Reference: Portland Museum of Art

REVIEW OF SITE PLAN

FOR THE PORTLAND ART MUSEUM EXPANSION

AT HIGH STREET AND CONGRESS SQUARE

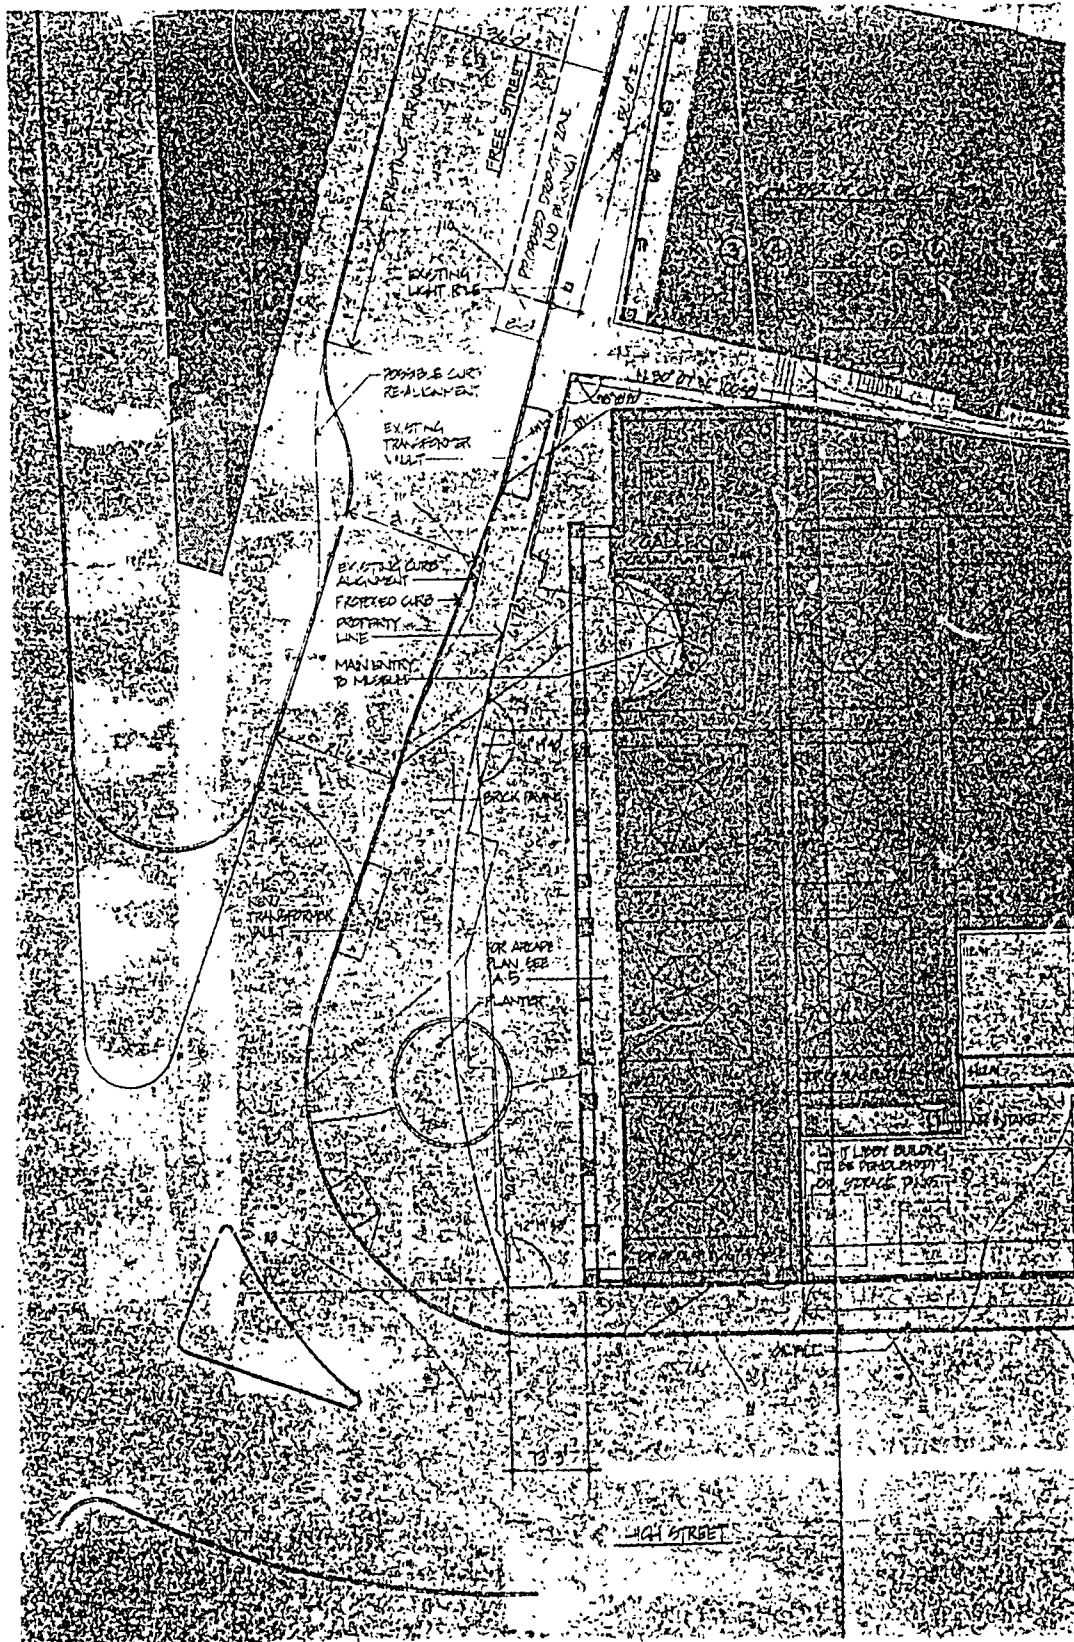
Please find enclosed a partial site plan of the Portland Museum of Art addition including the Congress Square/Free Street area we reviewed last Wednesday with you and Tom Valleau. We have designated the area in front of the Chamber of Commerce as a drop-off area, as per our discussion, therefore removing two spaces now metered. This zone measures approximately 56 feet on our drawing, although this dimension could be adjusted pending your review with Bill Bray.

We have also indicated a possible realignment of the curb opposite the Museum, as a means of further reducing congestion, in response to a suggestion made during our subsequent discussion with Mr. Bray on the site.

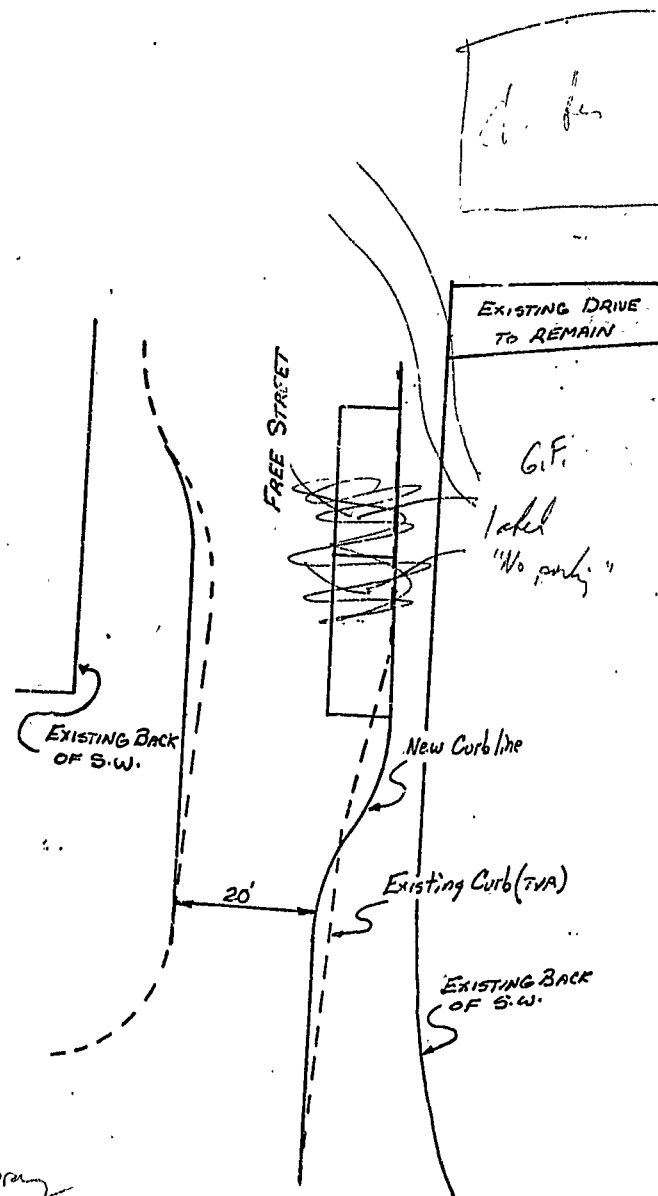
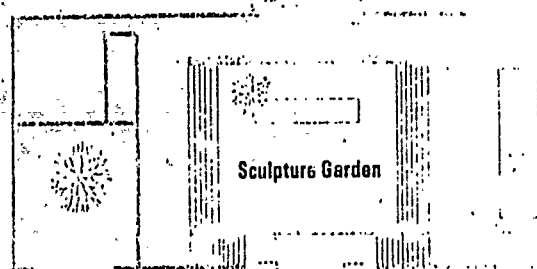
Pursuant to the Planning Boards request I have prepared preliminary design plans for providing on-street parking in the vicinity of the proposed Art Museum. Specifically, they requested that two (2) locations be examined: (1) Free Street at proposed Main entrance; (2) Spring Street between YWCA entrance and High Street. Attached are copies of each design concept for your review and transmittal to the Planning Board.

The Free Street plan would provide (2) two spaces directly in front of the proposed main entrance and (1) one additional space near the Chamber of Commerce Building. As shown on the attached sketch, a considerable amount of curb re-alignment and sidewalk work will be required. The (2) two spaces in front of the proposed entrance would be designated as 5 minute loading and unloading, and the (1) one space at the Chamber of Commerce will be designated for handicapped parking.

The parking plan for Spring Street would allow for (5) five auto spaces or (3) three bus spaces.

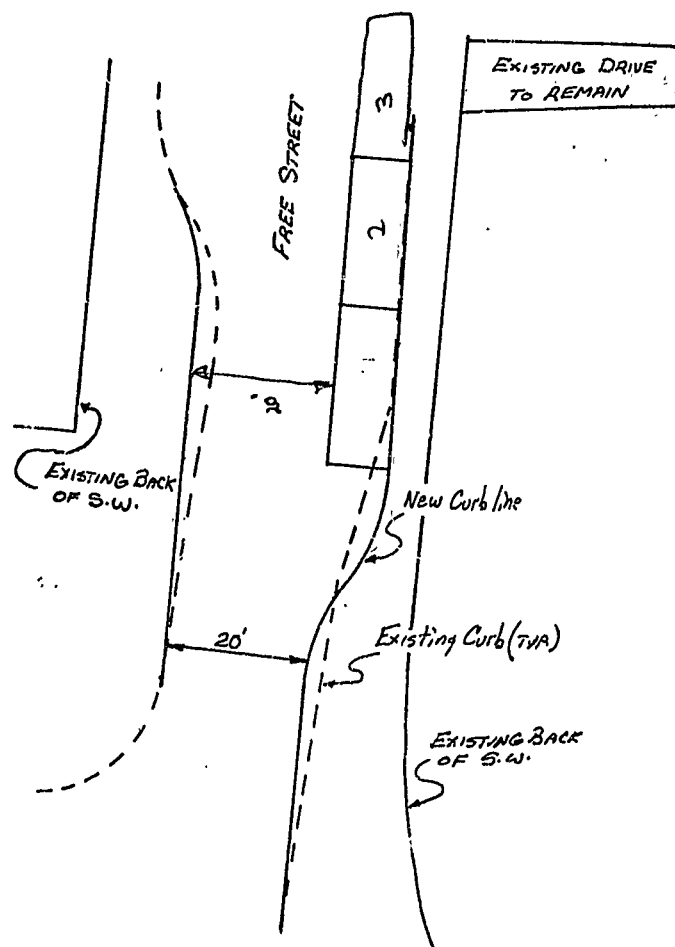
Pursuant to the Planning Boards request I have prepared preliminary design plans for providing on-street parking in the vicinity of the proposed Art Museum. Specifically, they requested that two (2) locations be examined: (1) Free Street at proposed Main entrance; (2) Spring Street between YWCA entrance and High Street. Attached are copies of each design concept for your review and transmittal to the Planning Board.

The Free Street plan would provide (2) two spaces directly in front of the proposed main entrance and (1) one additional space near the Chamber of Commerce Building. As shown on the attached sketch, a considerable amount of curb re-alignment and sidewalk work will be required. The (2) two spaces in front of the proposed entrance would be designated as 5 minute loading and unloading, and the (1) one space at the Chamber of Commerce will be designated for handicapped parking.

The parking plan for Spring Street would allow for (5) five auto spaces or (3) three bus spaces.

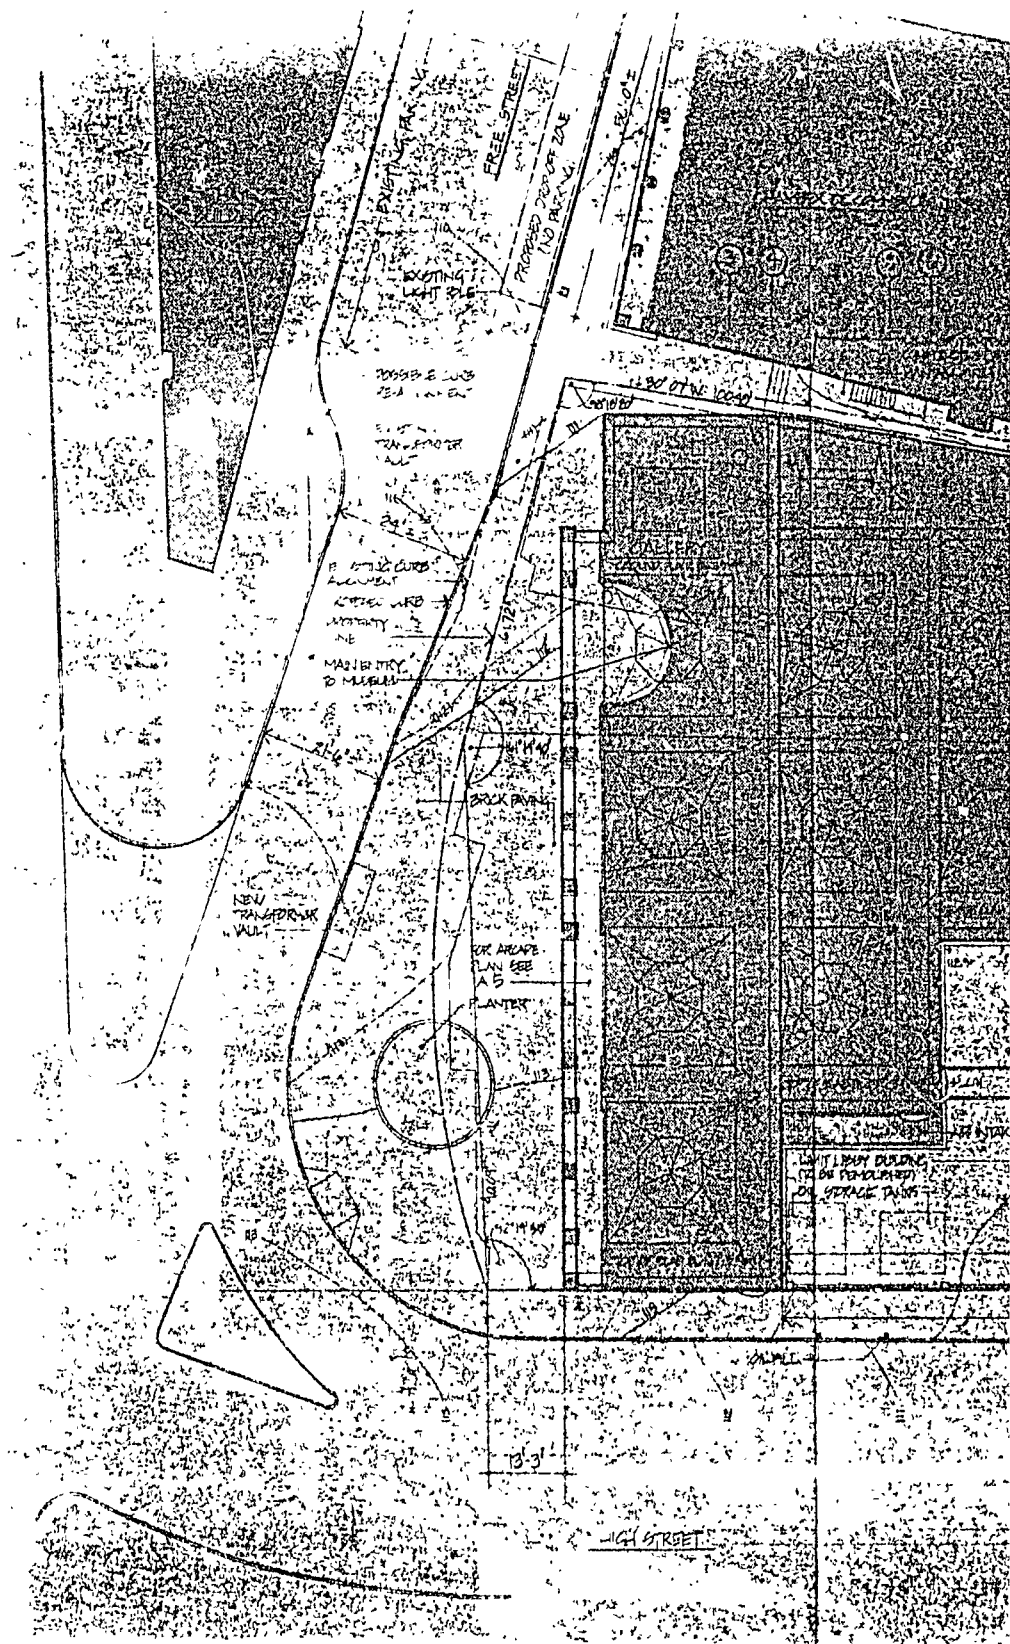
Please find enclosed a partial site plan of the Portland Museum of Art addition including the Congress Square/Free Street area we reviewed last Wednesday with you and Tom Valleau. We have designated the area in front of the Chamber of Commerce as a drop-off area, as per our discussion, therefore removing two spaces now metered. This zone measures approximately 56 feet on our drawing, although this dimension could be adjusted pending your review with Bill Bray.

We have also indicated a possible realignment of the curb opposite the Museum, as a means of further reducing congestion, in response to a suggestion made during our subsequent discussion with Mr. Bray on the site.
